TECHNICAL BULLETIN

No. 99-418-23

Curb Requirements for Weathertightness Warranties

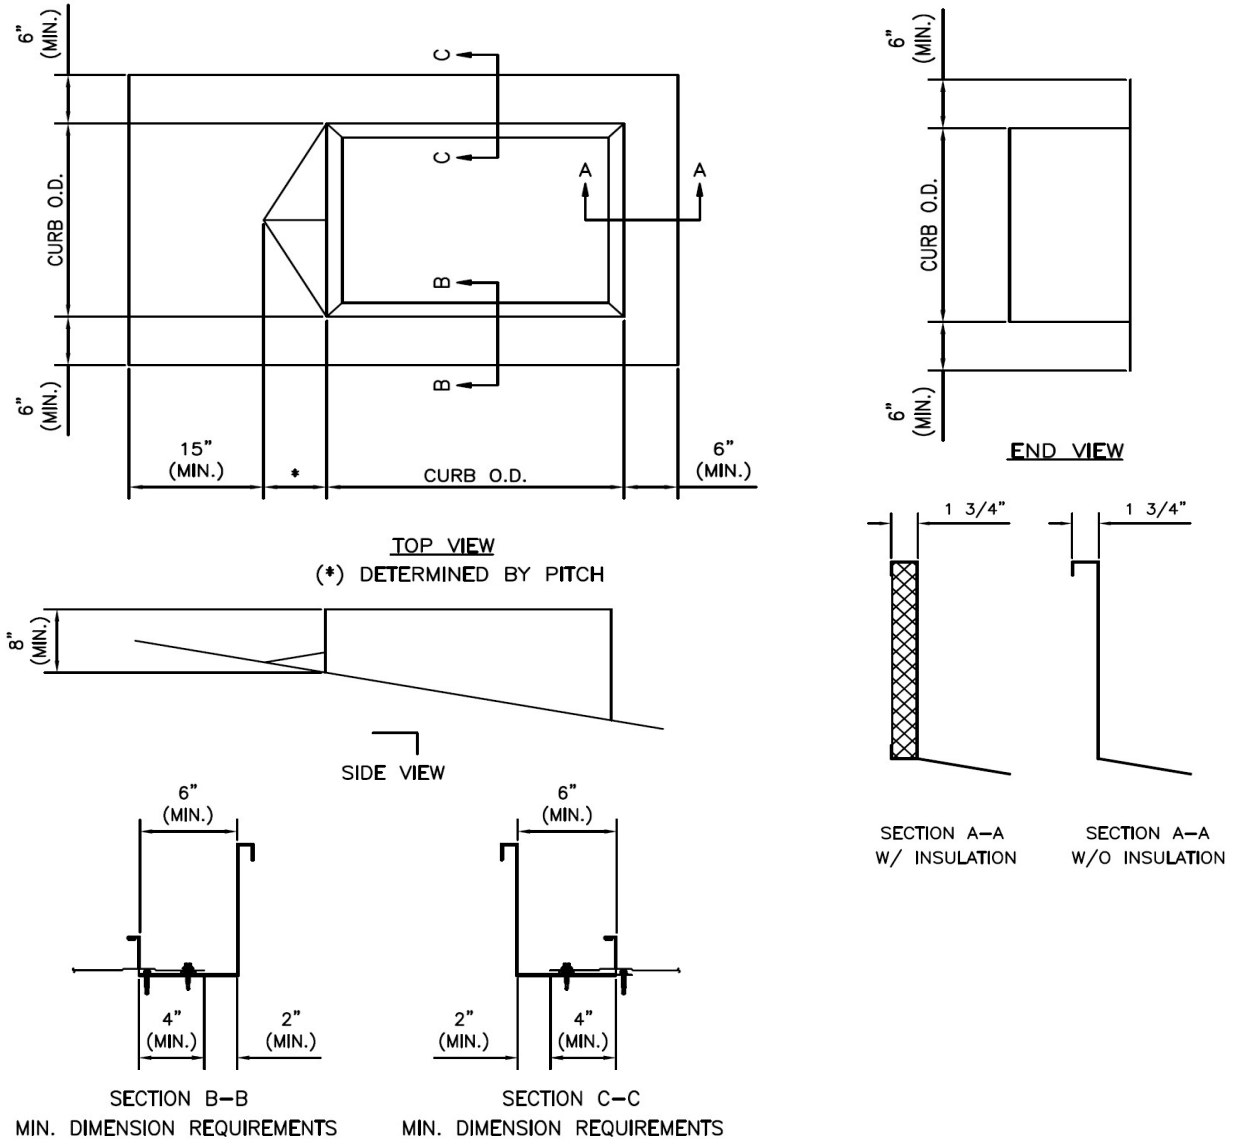
The upper flange of the curb should have a diverter. The distance from the uppermost part of the diverter to the end of the panel should be 12" (min) and the distance of the curb flange to the end of the panel should be 3" (min) from the uppermost part of the diverter.

If the curb is sitting in four (4) panels or less, the clearance from the curb wall to the panel seam (rib) should be 6" (min). For every panel above four (4), 1" must be added to the minimum clearance. The minimum distance from panel edge to the curb wall is 1". The minimum distance from panel edge to the curb flange is 2". (See Detail AA) The lower flange should be 6" (min) and needs to lap over the roof panels 3" (min). ***Clips cannot attach through the curb flanges***

All of these dimensions should be determined taking into account the unit being used and the substrate under it.
